October 2026

Notice of Discontinuation of LED Lighting Products

【Brightness】 *LWD=10mm

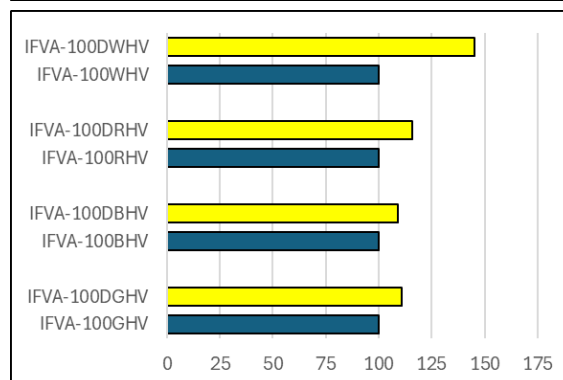
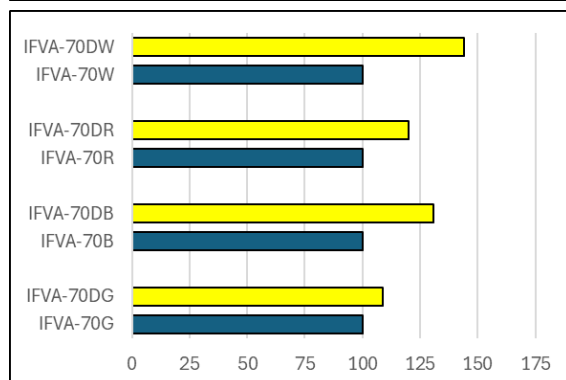
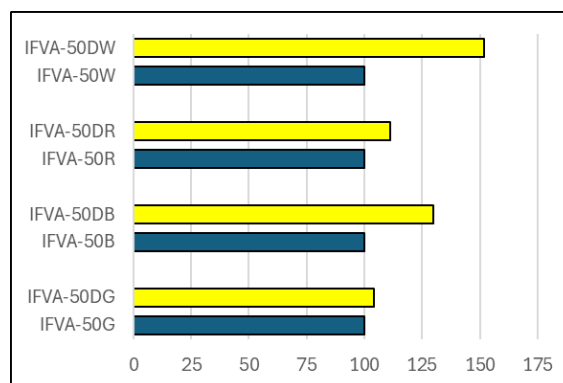
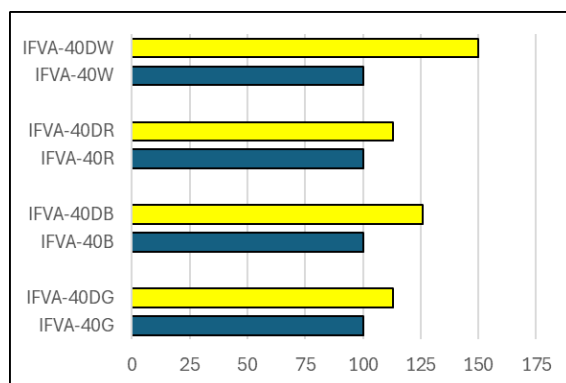
The power consumption of the size 40 white and blue models will change.

There are no differences between the discontinued models and their successors in light distribution characteristics or in the distribution and uniformity of illumination on the illuminated surface.
